DOMINION ENERGY KEWAUNEE, INC.
KEWAUNEE POWER STATION
LICENSE AMENDMENT REQUEST 252, OPERATION OF SERVICE WATER FLOW
TO COMPONENT COOLING HEAT EXCHANGERS

**LICENSE AMENDMENT REQUEST 252
OPERATION OF SERVICE WATER FLOW
TO COMPONENT COOLING HEAT EXCHANGERS**

**MARKED UP USAR PAGE
(FOR INFORMATION)**

**USAR Figure 9.6-2, "Service Water System – Flow Diagram Sheet 2"
Drawing Number E-2492, Revision H, Control Valves CV-31406, 31407**

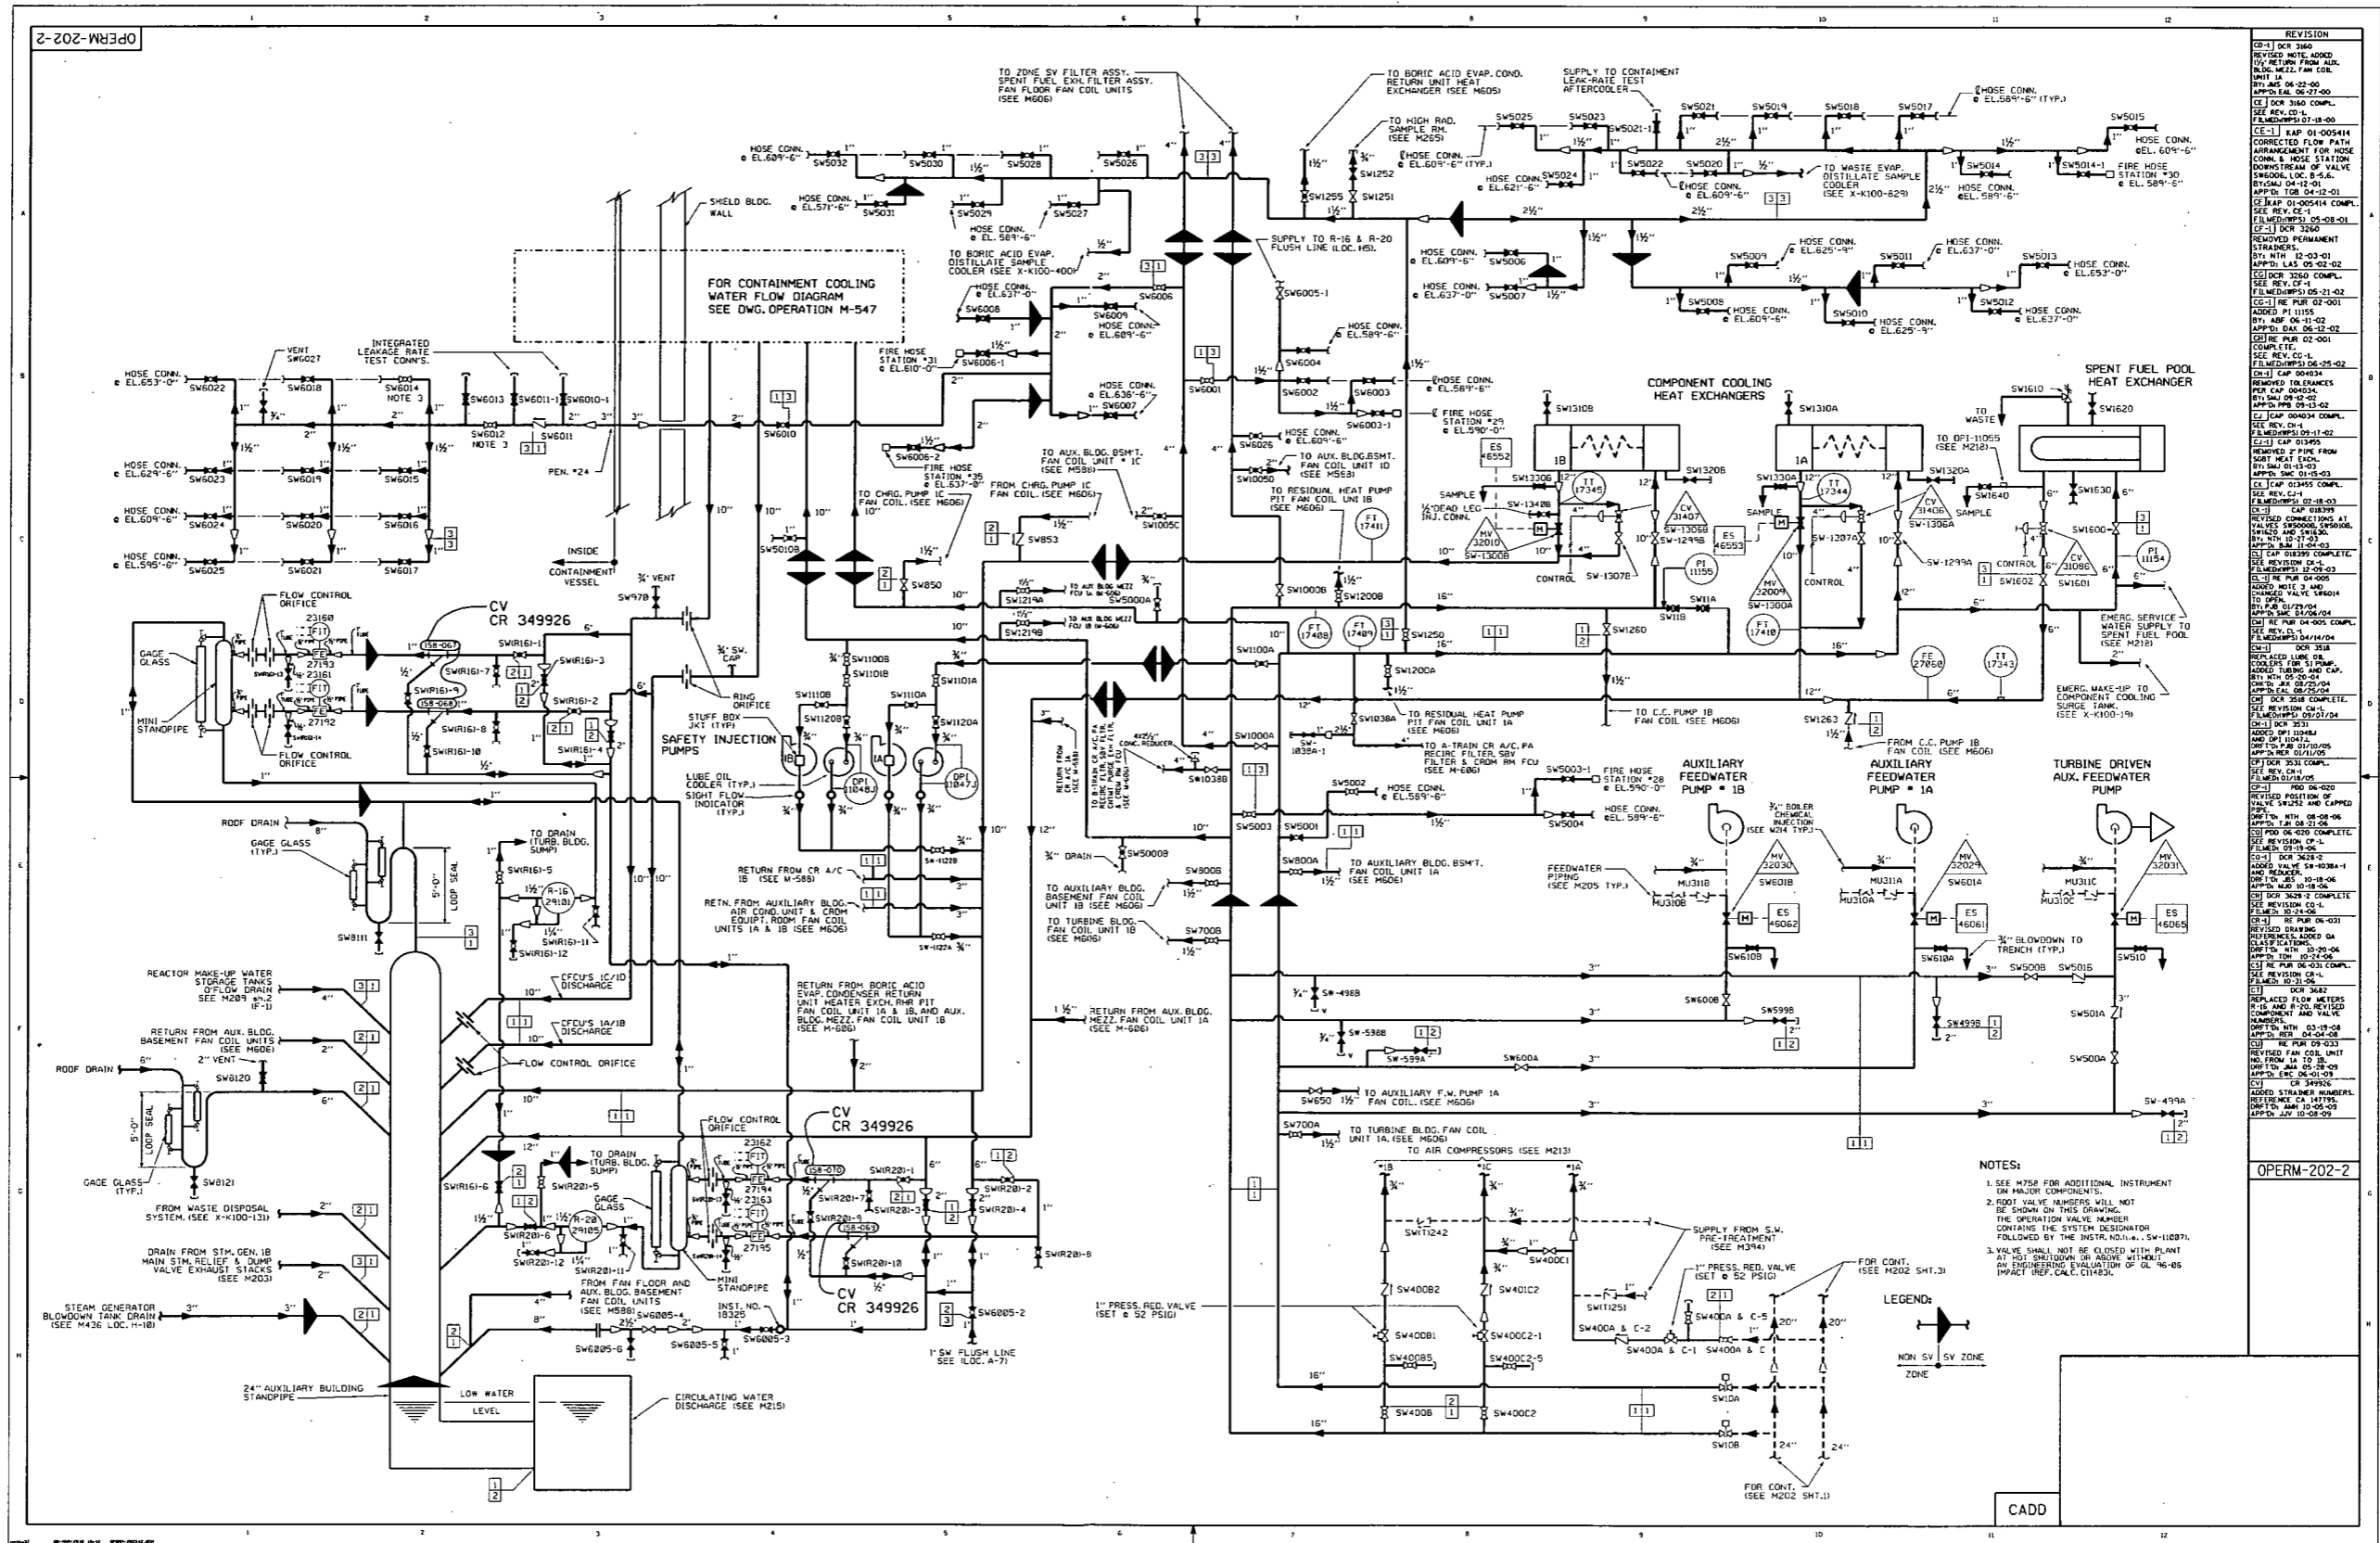
The design change modified the control circuits for SW control to CC heat exchangers' bypass flow control valves CV-31406/SW-1306A (Train A) and CV-31407/SW-1306B (Train B). The design change allows the control valves to continue to modulate and control SW flow to the CC heat exchangers during normal plant operation, automatically controlling the temperature of the CC water. However, the modified controls cause the SW-1306A/B valves to open automatically on an SI signal or a loss of their non-safety control power. A diagram depicting service water flow to the component cooling heat exchangers is contained in USAR Figure 9.6-2, which is enclosed for reference.

Figure 9.6-2 Service Water System-Flow Diagram Sheet 2

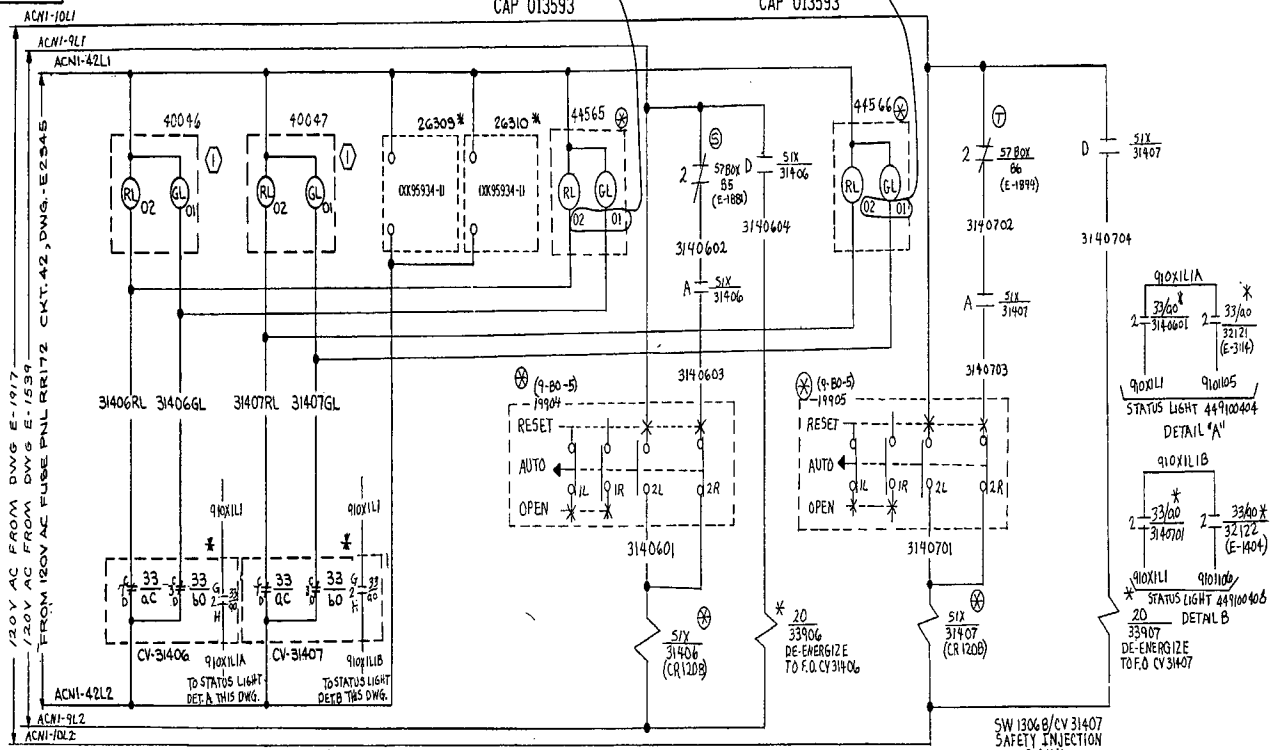
- Safety Injection Mode – The SI mode of operation is established when an SI signal is received. In the SI mode, power is interrupted to the SW-1306 SOVs, causing them to vent air from the valve actuators, which results in the SW-1306 valves being forced open by spring force. With the valves open, sufficient SW flow is provided to the CC heat exchangers to support event mitigation, with the exception of containment sump recirculation. When manually aligning for containment sump recirculation, the SW-1300 valves are opened by operators from the control room, as required by Emergency Operating Procedure ES-1.3, "Transfer to Containment Sump Recirculation."

During normal operation, the main service water return valves (SW-1300A/B) are maintained closed and component cooling water temperature is maintained by the service water bypass flow control valves (SW-1306A/B). Upon receipt of a safety injection signal, valves SW-1306 A/B will open automatically to provide the cooling water flow necessary to support the automatic plant response to the safety injection signal.

Valves SW-1300A and SW-1300B do not receive an open signal on safety injection. Although the capacity of the smaller (4-inch) service water bypass flow control valves is not sufficient to remove the heat load during the recirculation phase over the entire range of postulated accidents, these temperature control valves do have sufficient capacity to supply the needed service water flow to the component cooling water heat exchangers during the injection phase of safety injection, which allows additional service water to be available to supply the containment fan-coil units.
